SUB-003661-2026

Perch Creek Subdivision

- Subdivision approval to create one (1) legal lot of record from two (2) metes-and-bounds parcels.

DETAIL SITE PLAN

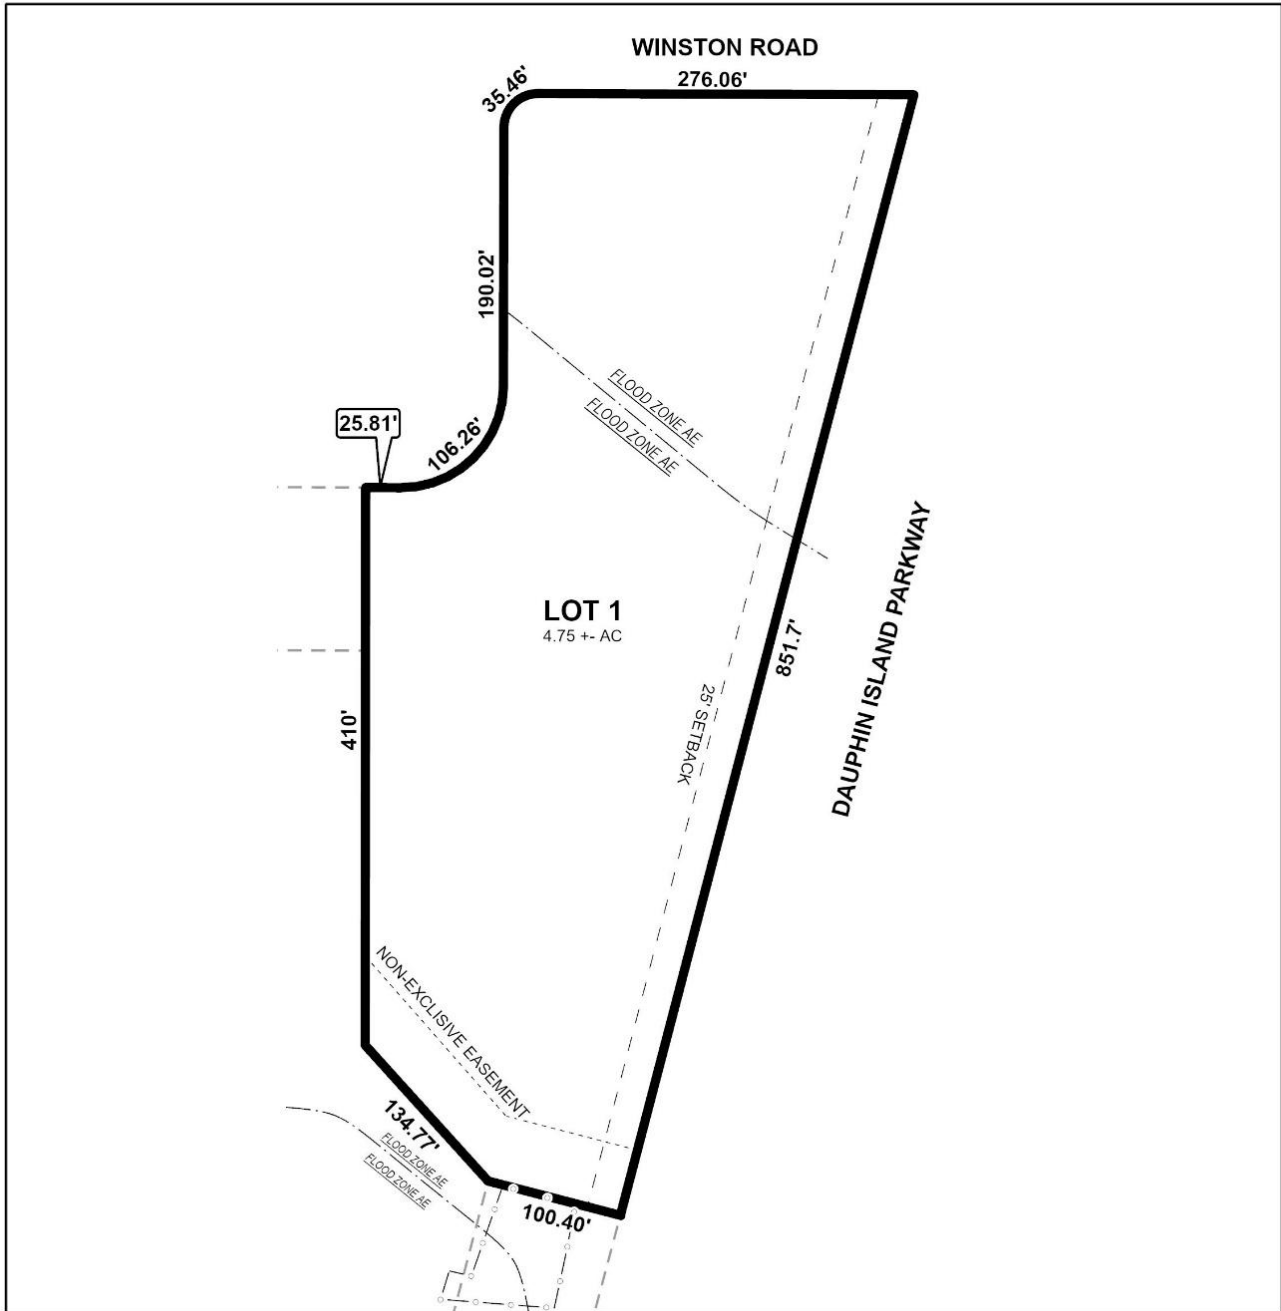
Section 6.C.7. of the Subdivision Regulations discourages lots with multiple street frontages, unless access is limited to one street per block face. The site plan for the recent Special Exception and Variance approvals indicates access is limited to Dauphin Island Parkway, suggesting a waiver of Section 6.C.7. may be appropriate.

Dedication of a 25-foot corner radius at the intersection of Dauphin Island Parkway and Winston Road should be required in compliance with Section 6.C.6. of the Subdivision Regulations, or as approved by the City Engineer and Traffic Engineering Director.

The existing 25-foot corner radius at the intersection of Winston Road and Winston Lane should be retained on the Final Plat, if approved.

A 25-foot front yard setback is illustrated along Dauphin Island Parkway on the preliminary plat, in accordance with Article 2, Section 64-2-14.E. of the UDC and Section 6.C.8. of the Subdivision Regulations; however, the required front yard setback is not illustrated along Winston Road or Winston Lane. If approved, a 25-foot front yard setback should be illustrated along all street frontages on the Final Plat, adjusted for any required dedication.

There is a non-exclusive gift easement for ingress and egress along the South property line. If approved, placement of a note on the Final Plat stating that no structure shall be constructed in any easement without the permission of the easement holder should be required.

1. Revision of the plat to illustrate right-of-way dedication sufficient to provide 50 feet from the centerline of Dauphin Island Parkway;
2. Revision of the plat to illustrate right-of-way dedication sufficient to provide 30 feet from the centerline of Winston Road;
3. Revision of the plat to illustrate right-of-way dedication sufficient to provide 25 feet from the centerline of Winston Lane;
4. Dedication of the corner radius at the intersection of Dauphin Island Parkway and Winston Road in compliance with Section 6.C.6. of the Subdivision Regulations;
5. Retention of the 25-foot corner radius at the intersection of Winston Road and Winston Lane;
6. Retention of the lot's size in both square feet and acres, or the provision of a table on the Final Plat providing the same information, adjusted for any required dedication;

7. Retention of the 25-foot front yard setback along Dauphin Island Parkway, adjusted for any required dedication;
8. Revision of the plat to illustrate a 25-foot front yard setback along Winston Road and Winston Lane, in compliance with Article 2, Section 64-2-10.E. of the Unified Development Code and Section 6.C.8. of the Subdivision Regulations, adjusted for any required dedication.

9. Placement of a note on the Final Plat stating that no structure may be constructed or placed within any easement without the permit permission of the easement holder;

10. Placement of a note on the Final Plat stating that the future development of the site is subject to the Peninsula Overlay provisions of Article 12 of the Unified Development Code;
